Access Compliance Report Public Rights-of-Way (Curb Ramps)

Main Street: AIROSO_ST Cross Street: ANDAZA_ST Location: NE

ADA ID: RPRK211203113510 Ramp Type: Type 1 - Perpendicular Initial Pass/Fail: Fail Overall Compliance: No Severity Score: 15

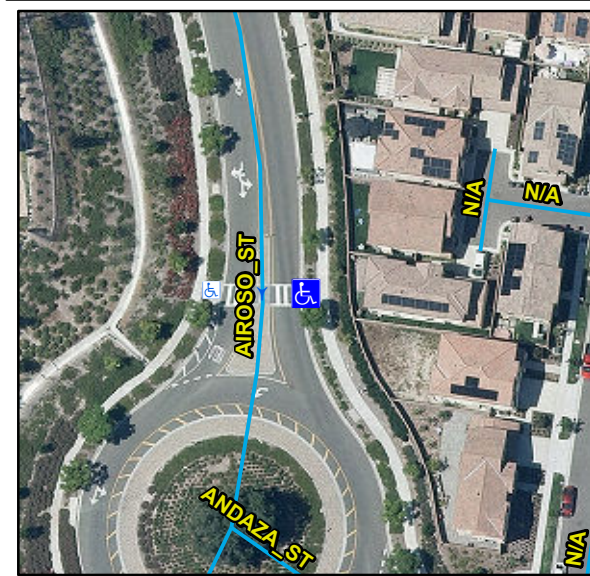
Compliance	Description	Data	Compliance	Description	Data
N/A	Ramp Length (in)	96	N/A	Flare Type LT	
Yes	Ramp Width (in)	62			N/A
No	Ramp Run Slope (%)	9.8	N/A	Flare Slope LT (%)	N/A
Yes	Ramp Cross Slope (%)	0.6	N/A	Flare Traversable LT	N/A
N/A	Landing Present	N/A	N/A	Flare Type RT	
N/A	Landing Length (in)	N/A			N/A
N/A	Landing Width (in)	N/A	N/A	Flare Slope RT (%)	N/A
N/A	Landing Run Slope (%)	N/A	N/A	Flare Traversable RT	N/A
N/A	Landing Cross Slope (%)	N/A	N/A	DWS Provided	N/A
N/A	Landing Movement Obstructed?	N/A	N/A	DWS Contrast	N/A
	Landing Movement Type	N/A	N/A	DWS Length (in)	N/A
N/A	Landing Shared	N/A	N/A	DWS Full Width	N/A
N/A	Clear Space	N/A	N/A	DWS Offset Left (in)	N/A
N/A	Clear Space To Crosswalk (in)	N/A	N/A	DWS Offset Right (in)	N/A
N/A	Marked Crosswalk 1	Yes	N/A	Marked Crosswalk 2	N/A
	Crossing 1 Direction	W		Crossing 2 Direction	N/A
	Marked Crosswalk 1 Width (in)	144		Marked Crosswalk 2 Width (in)	N/A

Possible Solutions:
Remove & Replace Entire Ramp.

OC Std/PROW:
R304.2.2, STD 1115
